Landscape Referral Response

Application Number:	DA2018/1514
Date:	19/06/2019
Responsible Officer:	Lashta Haidari
Land to be developed (Address):	Lot 100 DP 1015283 , 145 Old Pittwater Road BROOKVALE NSW 2100

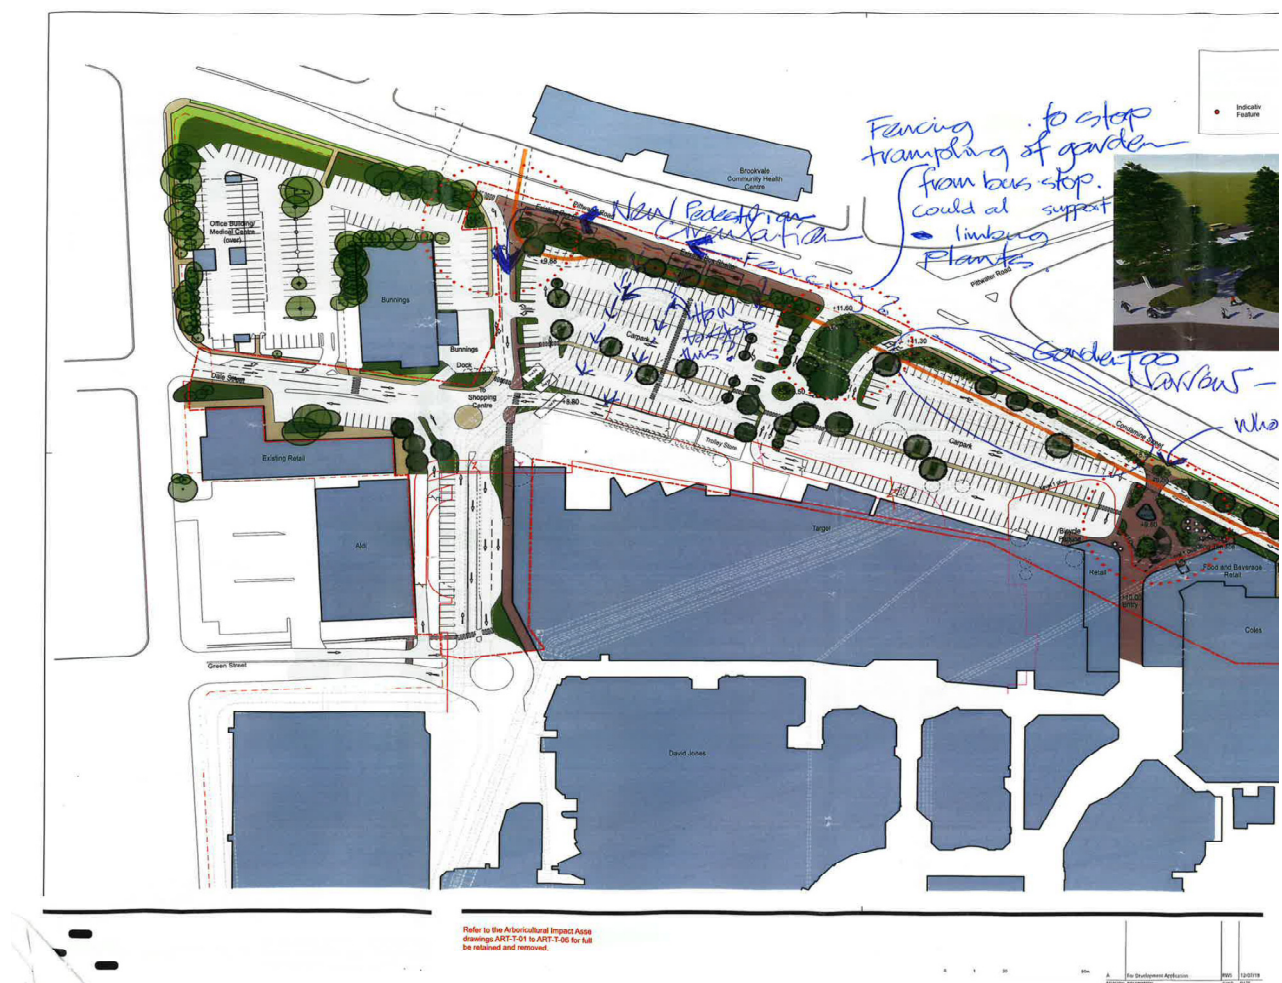
- Landscape area forward of the car-park opposite Warringah Golf Club:
DA2018/1514

The plans indicate reduction in the width of the landscape area with minimal landscape buffer to the carpark. The resultant area will be dominated by hard surfaces and cars. This is considered to be a poor response to the streetscape along a major arterial road. Insufficient width is provided to enable suitable planting to screen the car-park and integrate the bulk and scale of the development into the streetscape.
